SUBJECT: Finding of No Significant Impact (FONSI)  
Aiea Public Library Site Feasibility  
TMK 9-9-05:10 and 25, Ewa District, Oahu, Hawaii

\* **Aiea Public Library Site Feasibility** \*  
Final Environmental Assessment  
(DAGS Job No. 12-36-6280)

10.0	COMMENTS AND RESPONSES .....	58
10.1	Comments Received on the Draft EA .....	58
10.2	Draft EA Comment Letters and the Applicant's Responses .....	58

Figure 2  
TAX MAP KEY

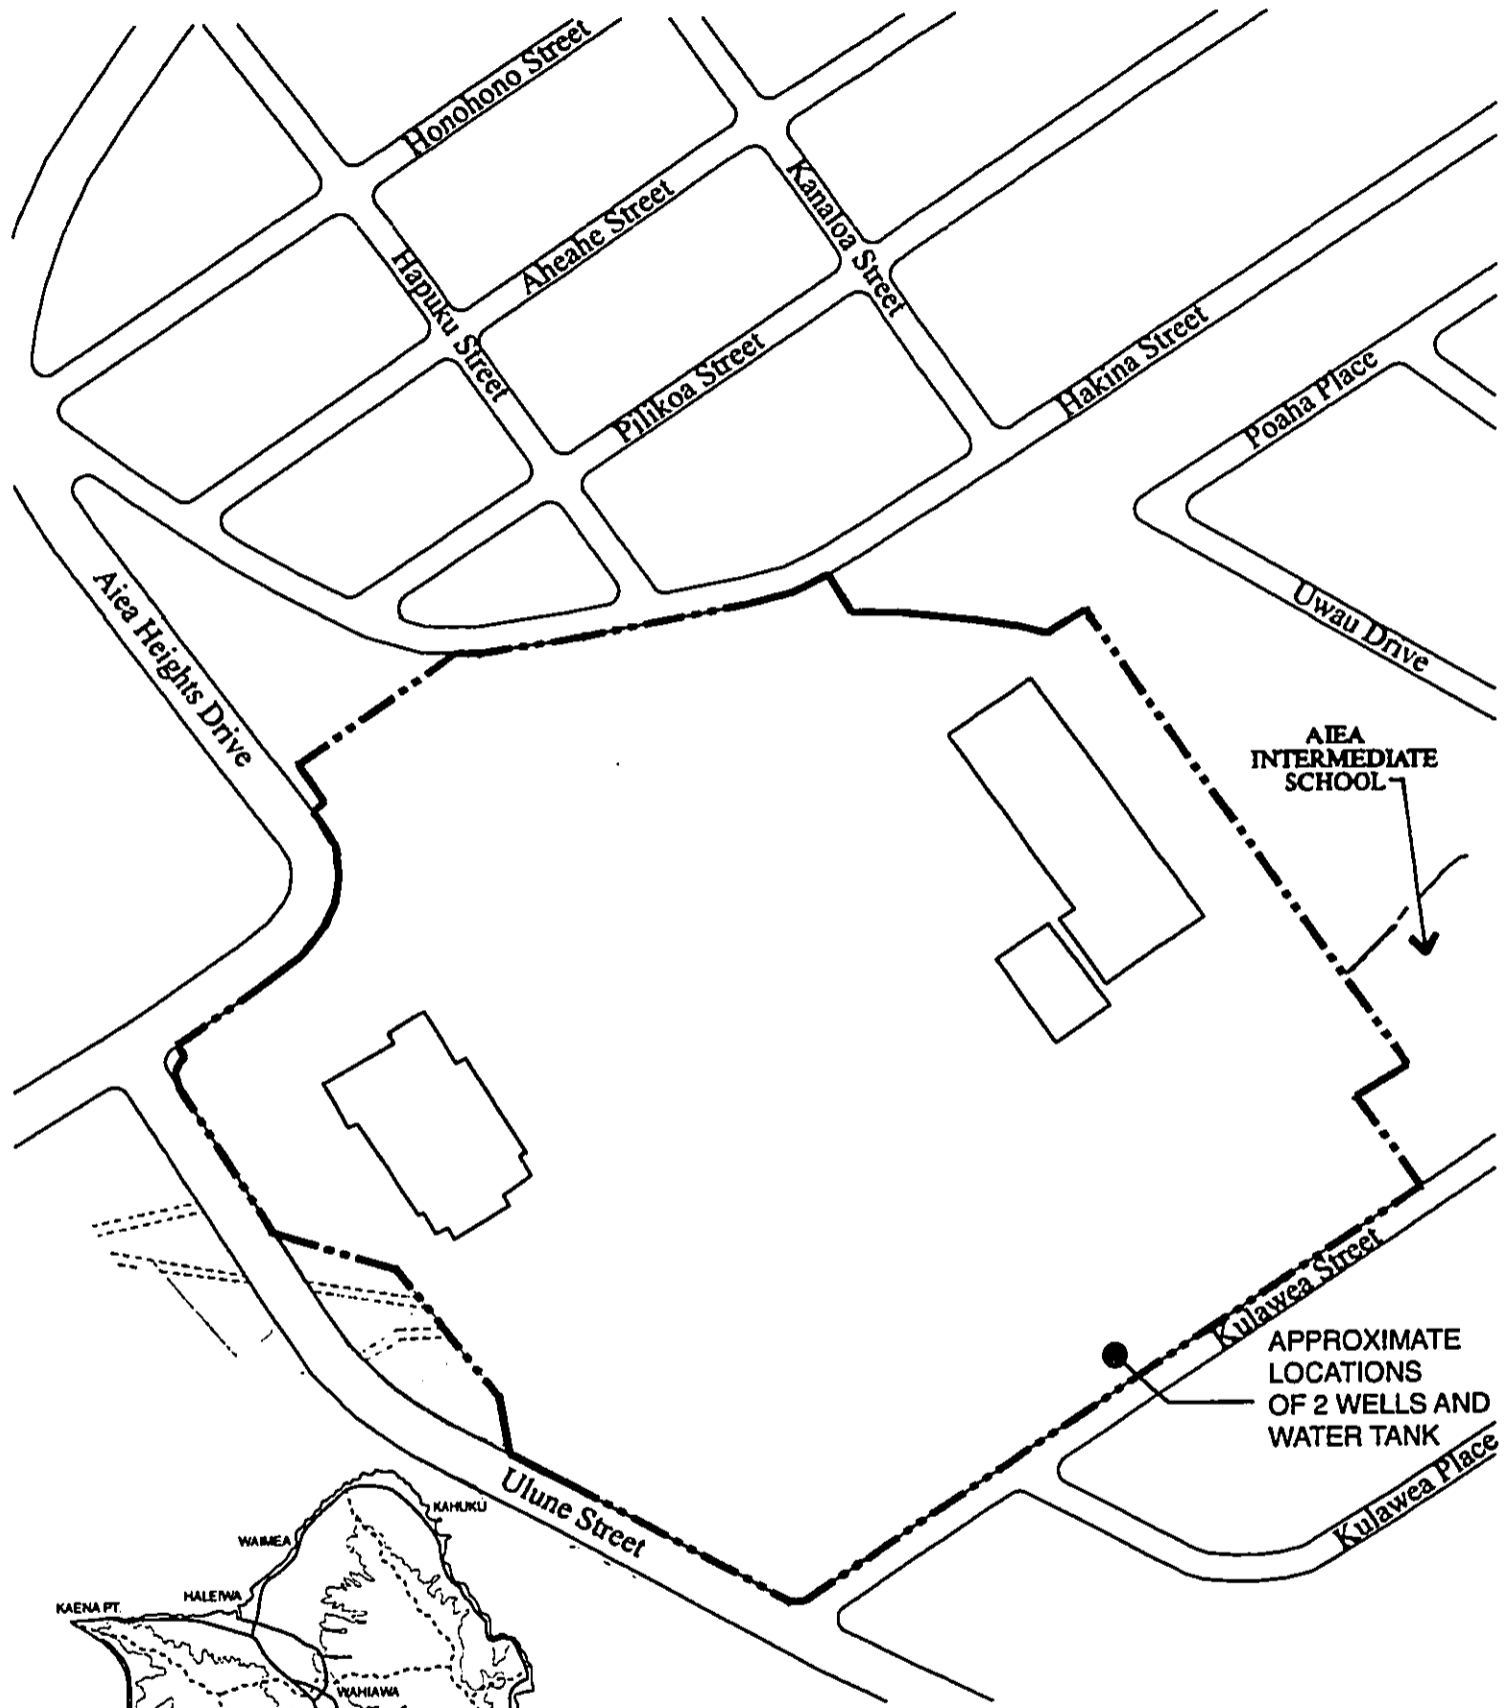
4. Project Area: The project area is stated as 16.447 acres. This contradicts the information provided on Figure 2 and in the first sentence of Section 2.1.3. The final EA should clarify that the area of TMK: 9-9-5: 10 is 16.447 acres, and that of TMK: 9-9-5: 25 is 2.953 acres, for a total project area of 19.400 acres.

The final EA will be revised accordingly to depict the information regarding the recent consolidation and resubdivision of the subject properties and the new parcels; TMK 9-9-5: 10 and 25 (revised Figure 2). It is noted that previous EA discussions referencing the subject parcels were incorrectly based on the TMK information from the EIS document for the proposed Aiea Sugar Mill commercial developments by Crazy Shirts (prior to the recent consolidation and resubdivision of the subject properties).

Figure 3  
CONCEPTUAL SITE PLAN

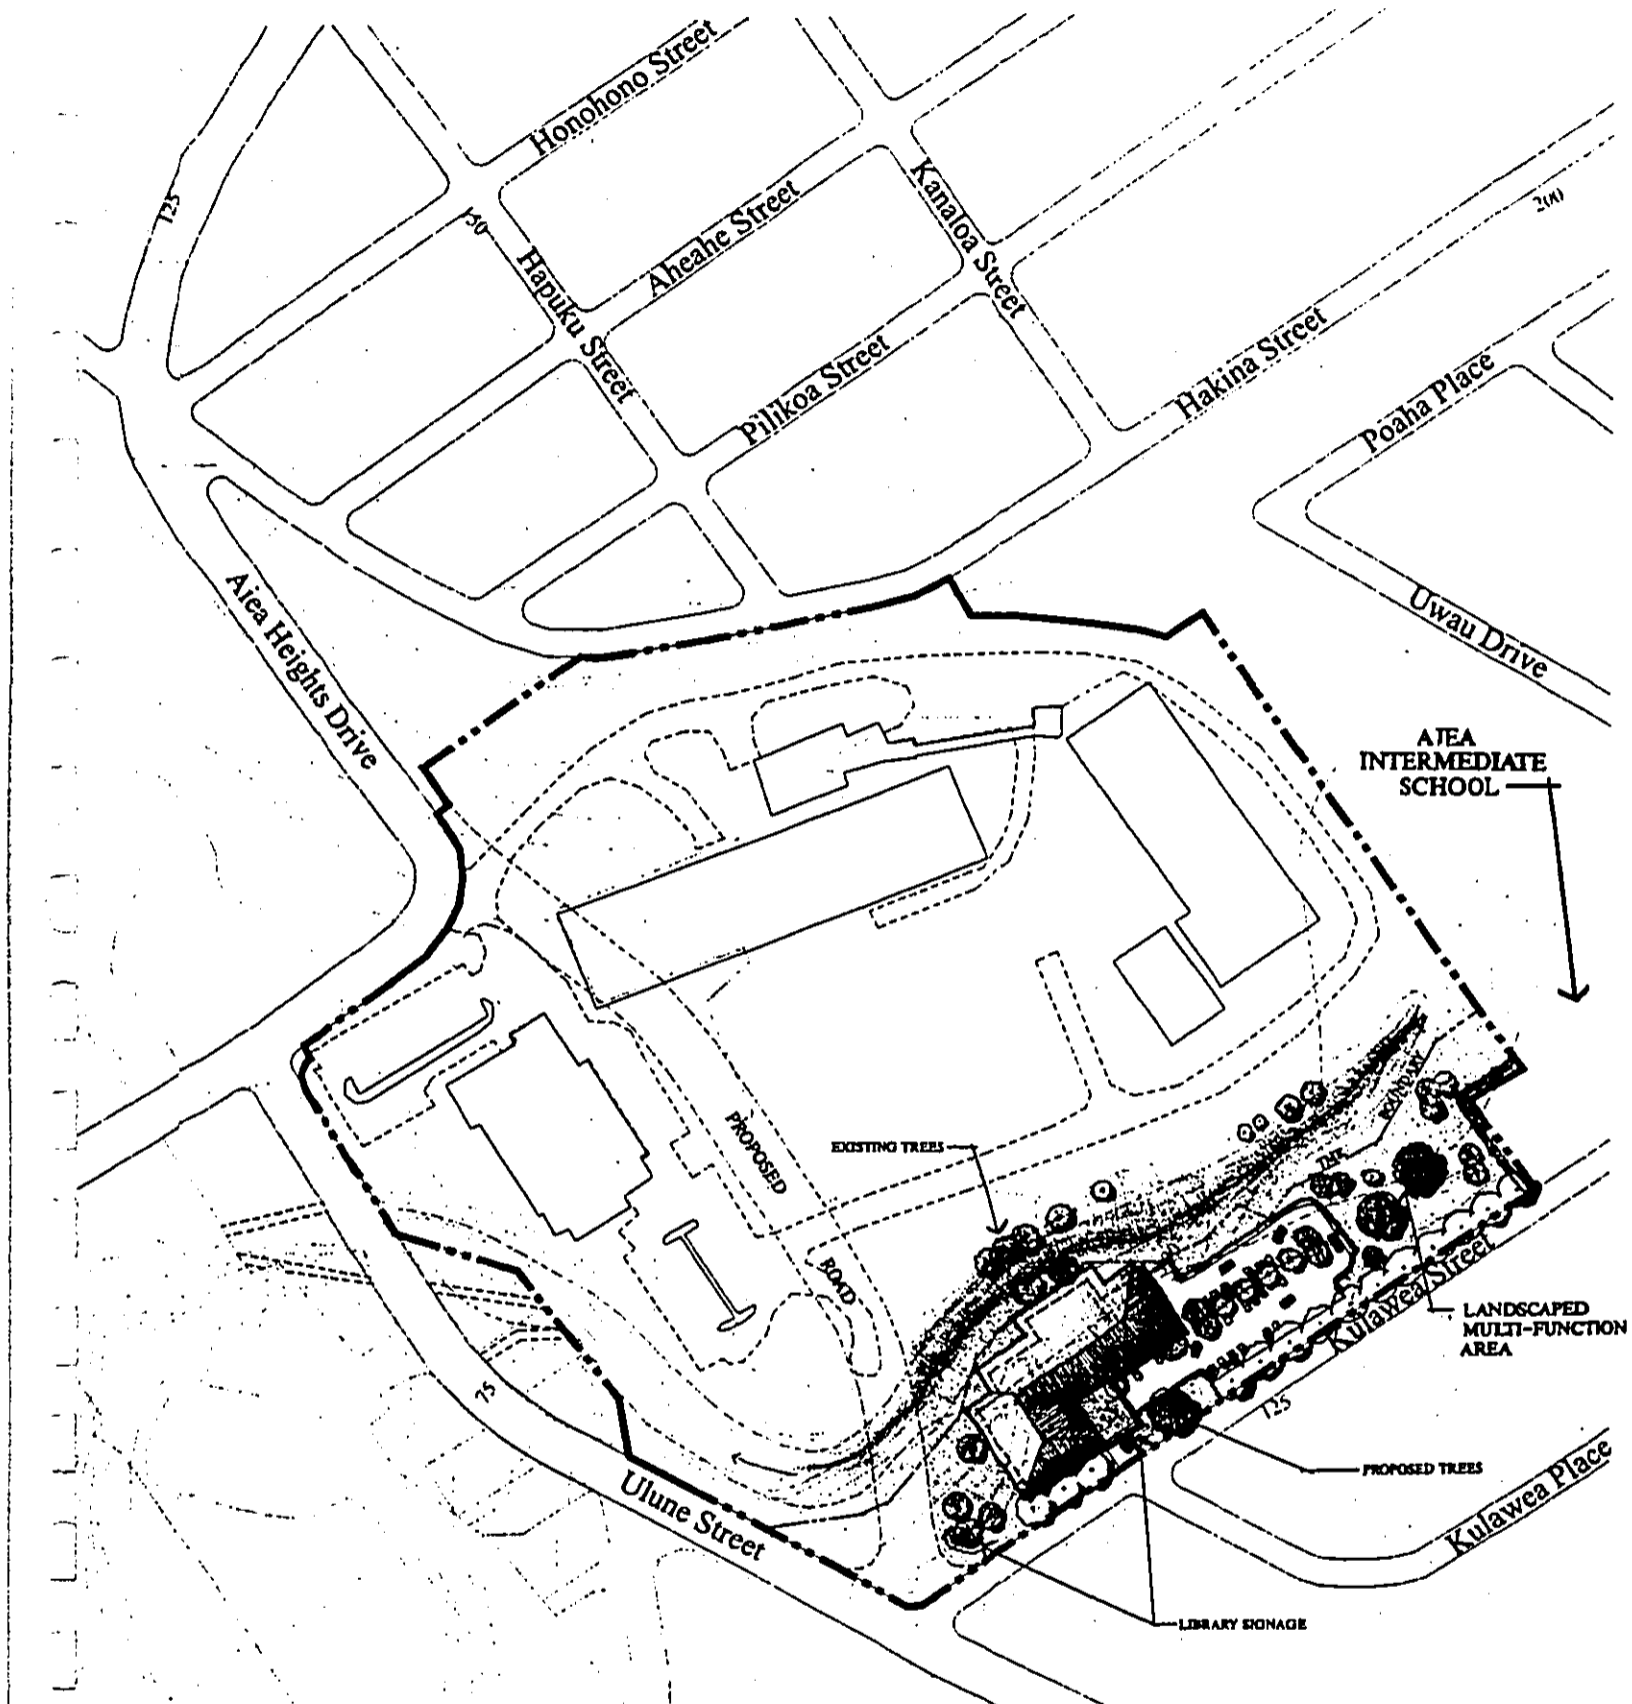
It would be helpful if the final EA showed the flood hazard zone on Figure 3. Conceptual Site Plan, to show the relationship of the facility to the potential hazard.

10. Sec. 2.5, Environmental Characteristics, 3rd paragraph, 2nd sentence: This sentence notes on-site retention areas will be used to manage run-off. The final EA should discuss the anticipated capacity and design features of these on-site retention areas; and the anticipated locations of these areas should be indicated on the conceptual site plan (Figure 3).

33. Sec. 5.7, The Aiea Empowerment Zone Strategic Plan, 4th paragraph, last sentence: The proposal to provide the Community and Biotech Gardens is not reflected in the conceptual site plan presented in Figure 3, and is not discussed elsewhere in this document. The final EA should clarify whether these gardens are intended to be part of the proposed action.
34. Sec. 5.7, The Aiea Empowerment Zone Strategic Plan, 5th paragraph: The final EA should clarify what the potential noise conflicts might be and why those potential noise conflicts would be of greater consequence for the Elderly Dare Care/Residential project than for the proposed library.

We wish to emphasize that the Conceptual Site Plan depicted as Figure 3 is conceptual only. The actual architectural plans, building footprint, and areas with impermeable surfaces will likely be much different once the design-development phases of the project are completed. Consequently, it is premature to identify and size retention areas at this level of planning. However, the likely location for a retention area could be located between the parking lot and the Aiea Intermediate School property.
